- 8. Thorsland Subdivision Addition No. 1
KPB File 2022-069R1**

KPB File 2022-069R1

ITEM 8 - THORSLAND SUBDIVISION ADDITION NO 1

STAFF REPORT

**Thorsland Subdivision
Addition No. 1**

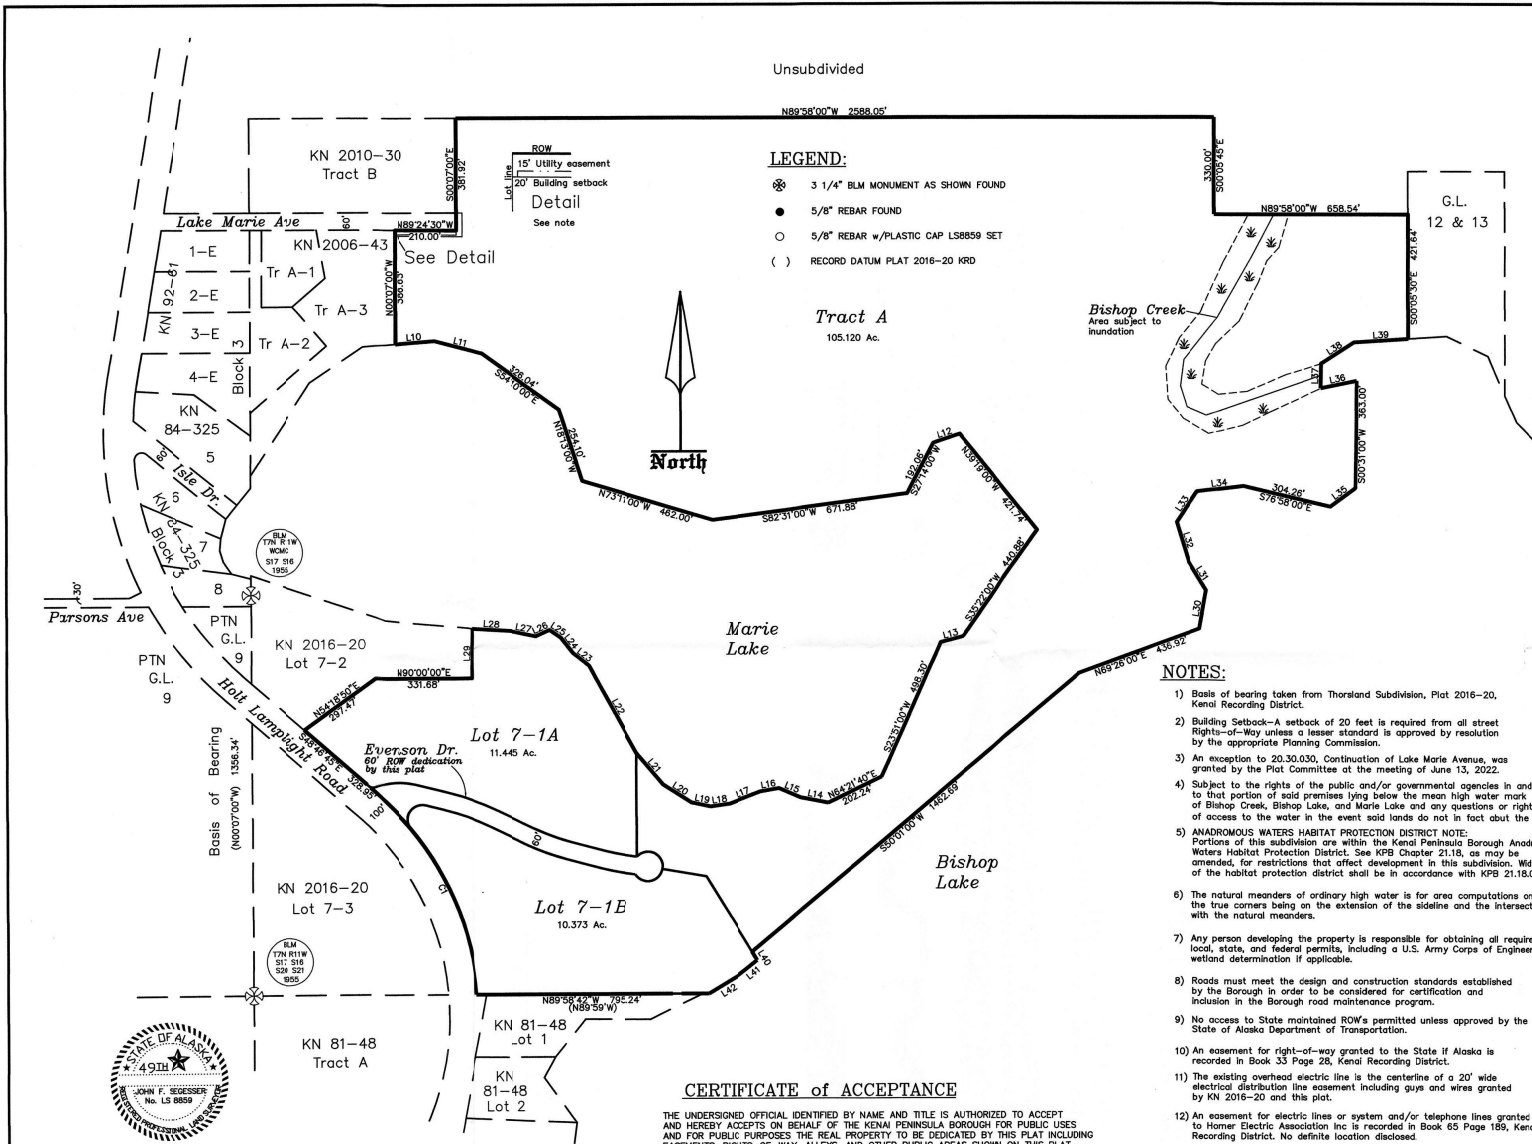
Staff recommendation: *Both sheets should match legal descriptions*

Staff recommendation: *The certificate of ownership will need to be revised to be on behalf of the estate and provide the name of the executor or representative. Comply with 20.60.190.*

Surveyor's Discussion: I am resubmitting this and would like to request an exception to surveying and monumentation for Tract A. Thank you.

This is only a request for Tract A. The other two lots being created as well as the new right-of-way dedication will require surveying and monument placement. As there are surveyed lots within the northwest area as well as a right-of-way dedication, staff would like for the shared lot lines to have monuments found and if missing reset. If this exception is granted the surveyor will not be required to survey the remaining portions of Tract A and will use record or computed data for the remainder of the lot. No monuments will be placed along the north, east, or near the lakes.

Staff reviewed the exception request and recommends granting approval subject to locating and setting monuments with the northwest corner abutting existing subdivided lots and Lake Marie Avenue dedication.

Staff recommendation: place notes on the final plat indicating any exceptions granted by the Plat Committee with the meeting date.

Thorland Subdivision Addition No. 1

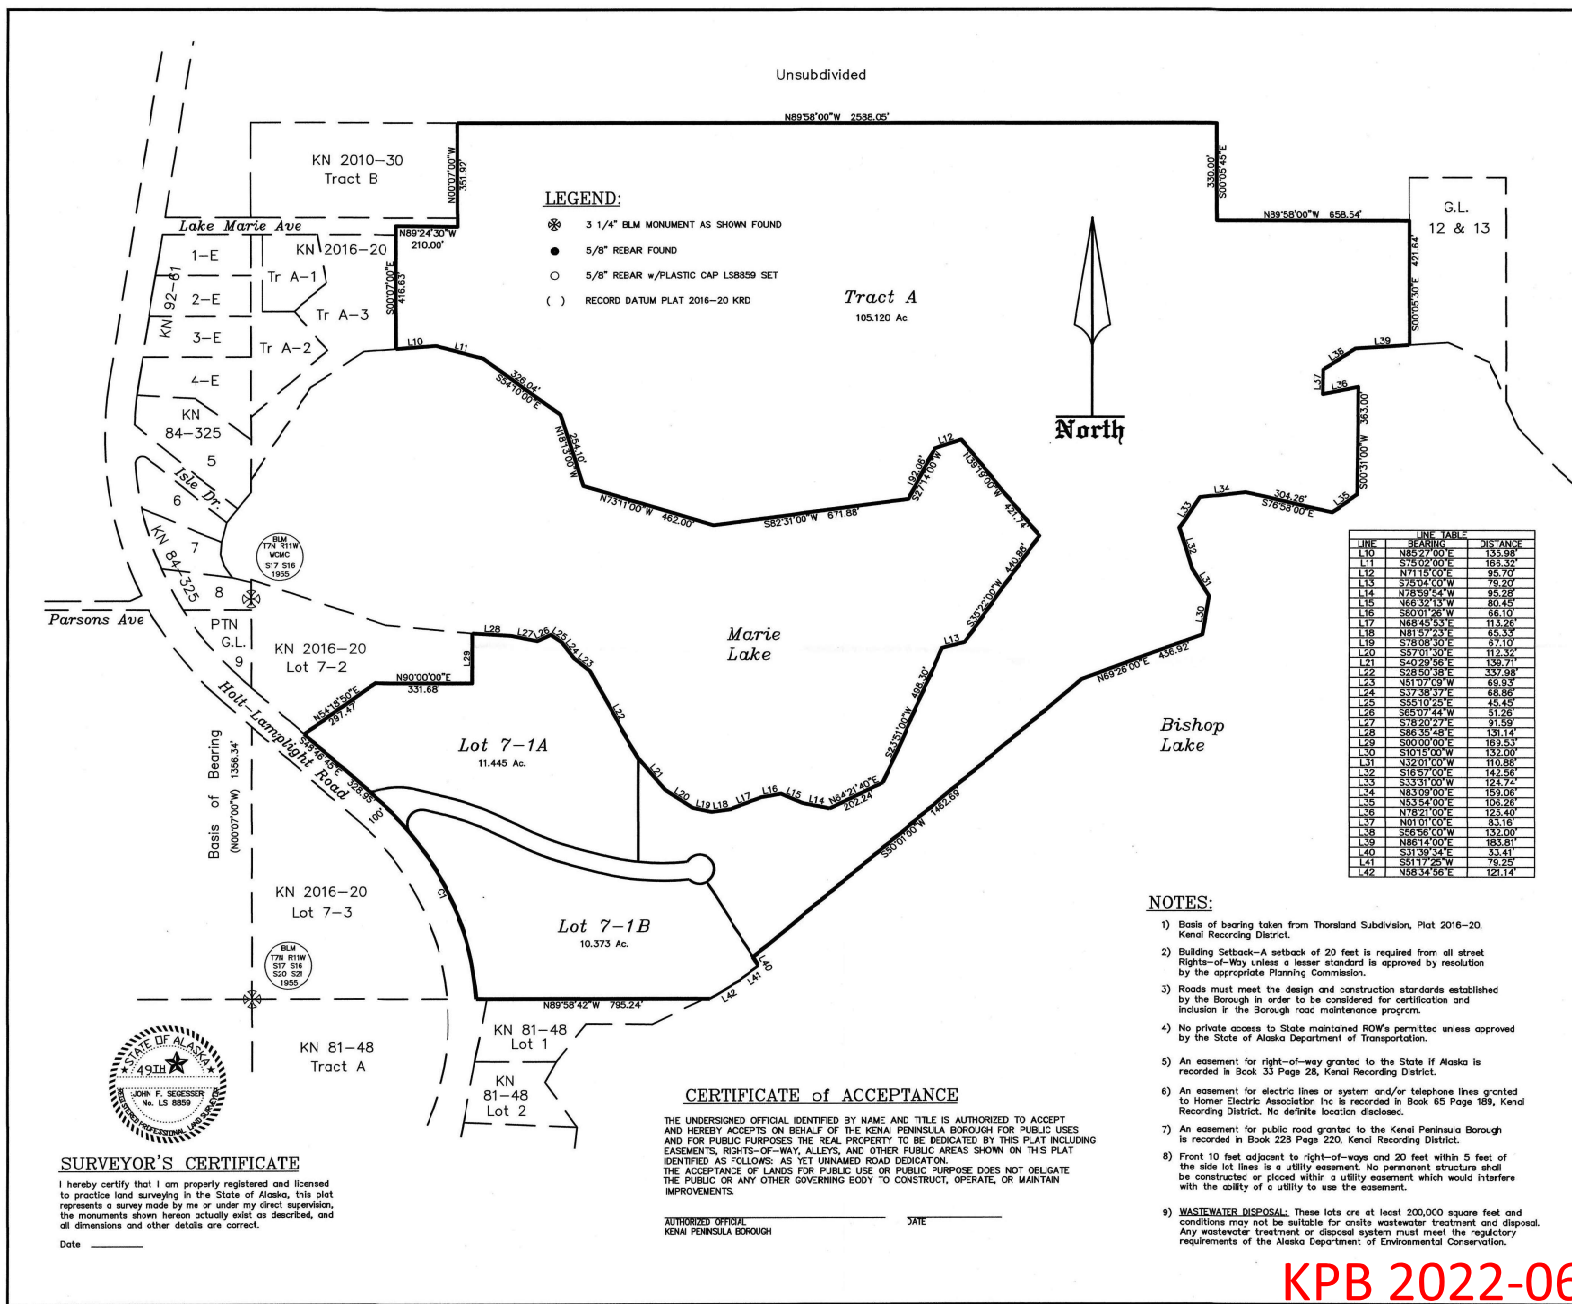
The depiction of Lake Marie Avenue on sheet one appears to need revision. The current depiction indicates that the right-of-way narrows to 30 feet that is only dedicated on the northern side of the right-of-way. Senior Shore Addition Number 2, Plat KN 2010-30, created Tract B to the north and also dedicated a full 60 foot wide right of way from the eastern edge of Tract A-3 to the eastern edge of Tract B. ***Staff recommends the depiction of Lake Marie Avenue be revised to show existing dedications.***

- Staff recommendation:** Provide width labels for Lake Marie Avenue and Isle Drive on sheet 1. Provide a label for Holt Lamplight Road that includes the plat number for the right-of-way information, Plat KN 85-44. Remove the hyphen from Holt Lamplight labels.

Staff recommendation: The proposed dedication is atop a private road that had been named Evenson Drive. Include the name for the new dedication on both sheets and a width label is needed on sheet 1.

Staff recommendation: Sheet 1 – The lots adjacent to Holt Lamplight Road along the east have block designations that should be added, update the recording number for Tract A-3 that is adjacent to the plat, provide a label width for Parsons Avenue, review the depiction of the Parsons Avenue intersection and update as needed, revised the depiction for the lot south of Parsons Avenue as this appears to be two lots in that area and both will need labels.

Staff recommendation: The certificate of ownership will need to be revised to be on behalf of the estate and provide the name of the executor or representative. Comply with 20.60.190.

Thorland Subdivision Addition No. 1

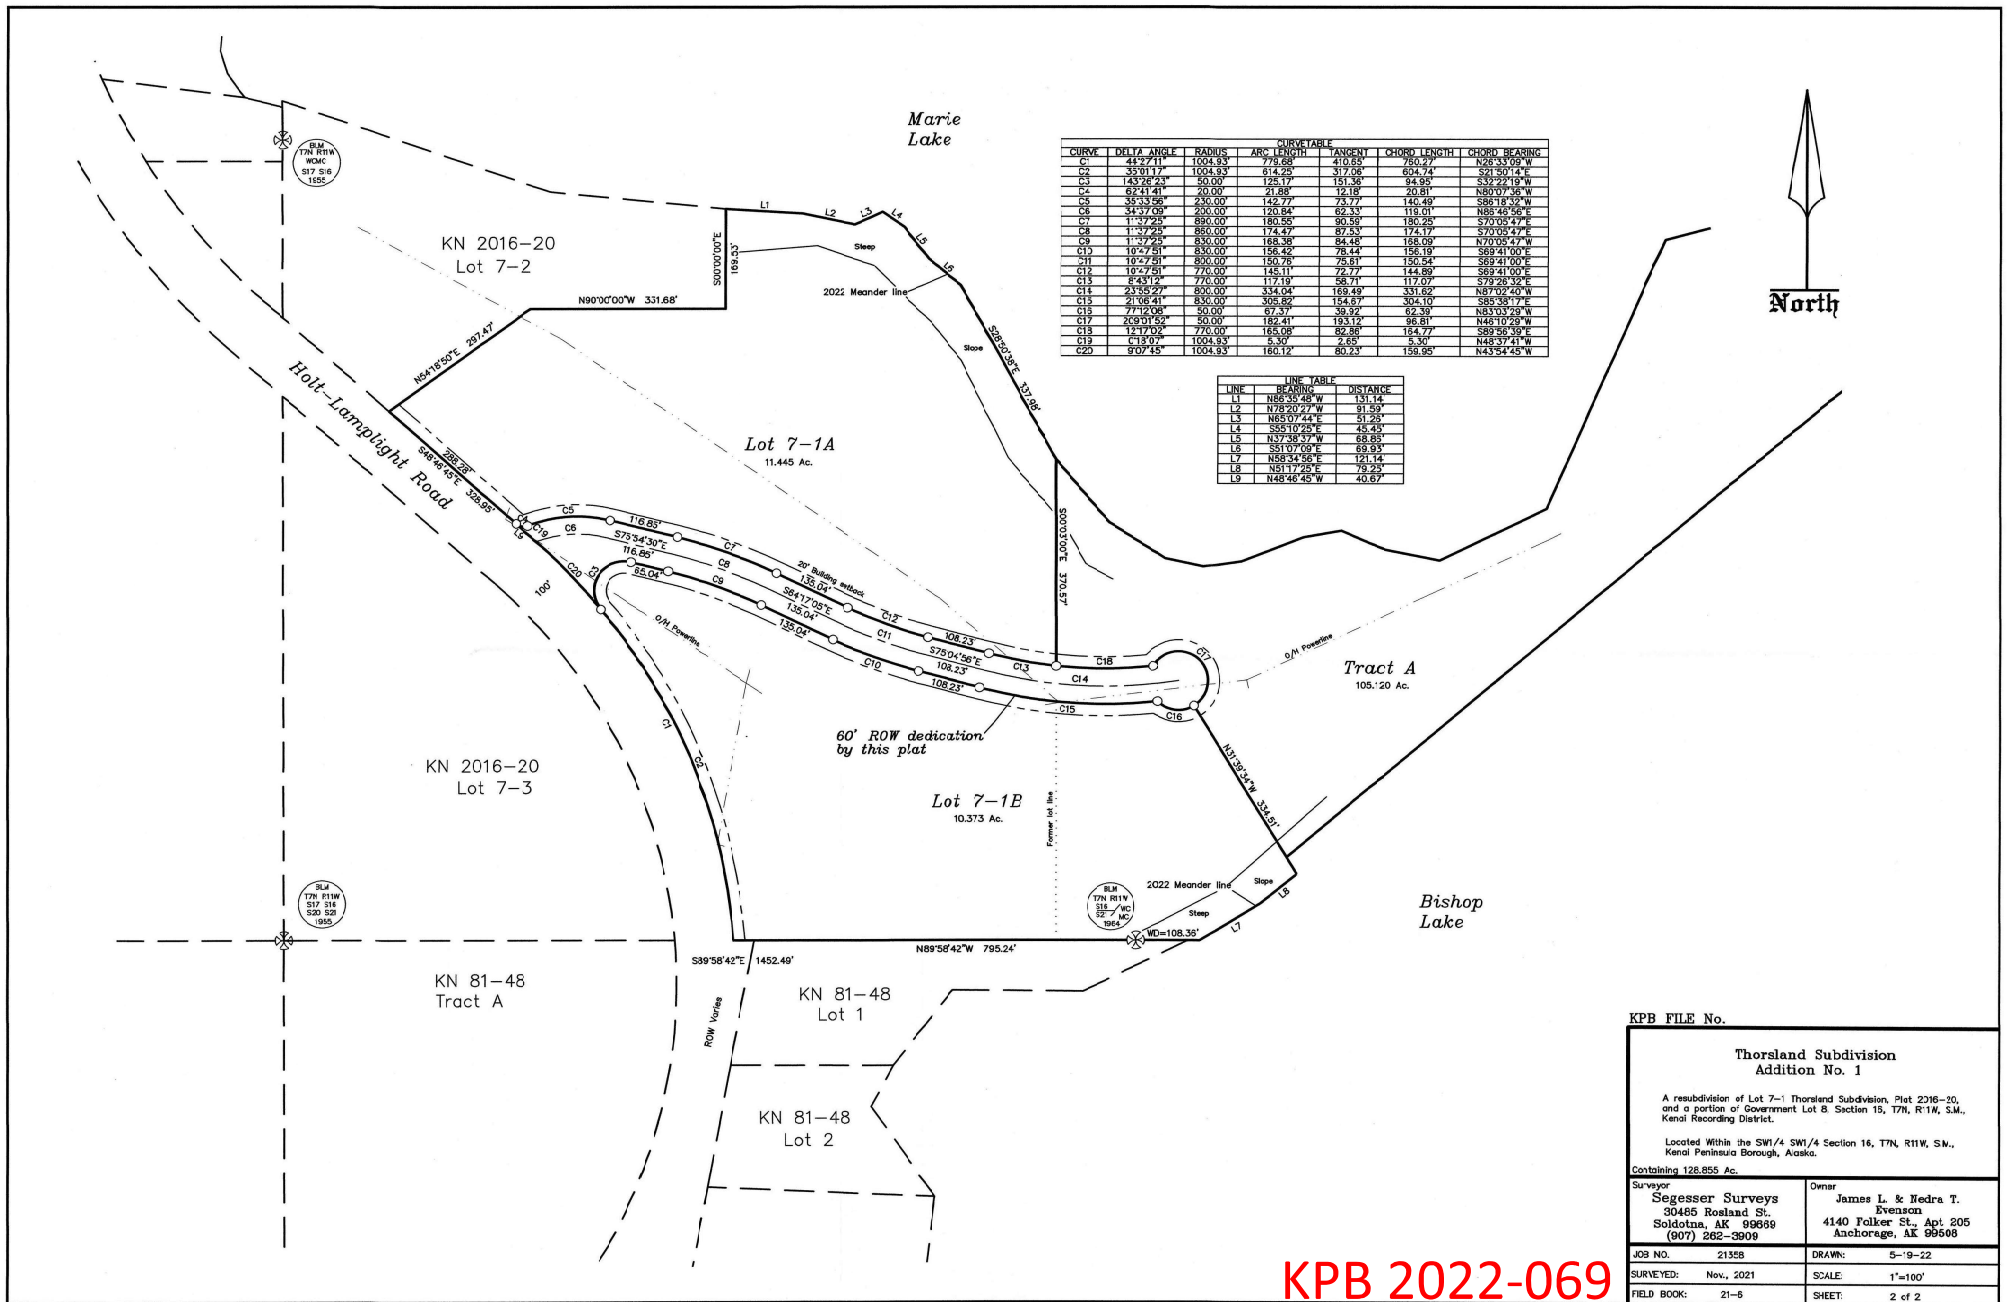
The parent Lot 7-1 had some easements granted with the recording of Thorsland Subdivision, Plat KN 2016-20. The parent plat granted 15 foot utility easements along Holt Lamplight Road. **Staff recommends** sheet two depict the 15 foot utility easements and provide a note stating they were "granted per KN 2016-20."

Sheet 2 – Update the depiction of the lots across Holt Lamplight Road and provide labels, and add labels for the lots adjacent to Lot 7-2.
